Amendments to the Drawings

Remarks/Arguments

Drawings

FIG 1
"PRIOR ART"

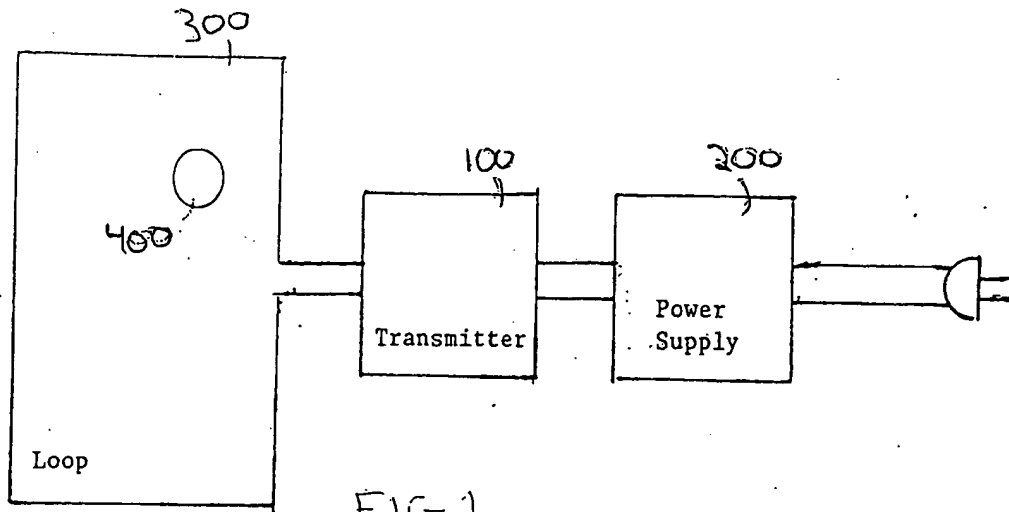
Figures 1 and 6 are objected to under MPEP 608.02(g) as lacking the legend "Prior Art". In response, Figures 1 and 6 are amended to include the legend "Prior Art". Replacement and annotated sheets showing these amendments are attached.

The attached two sheets of drawings includes changes to Figs. 1 and 6. The first sheet, which also includes Fig. 2, replaces the original sheet including Figs. 1 and 2. In Fig. 1, the legend "Prior Art" has been added. The second sheet replaces the original sheet including Fig. 6 and adds the legend "Prior Art" to Fig. 6.
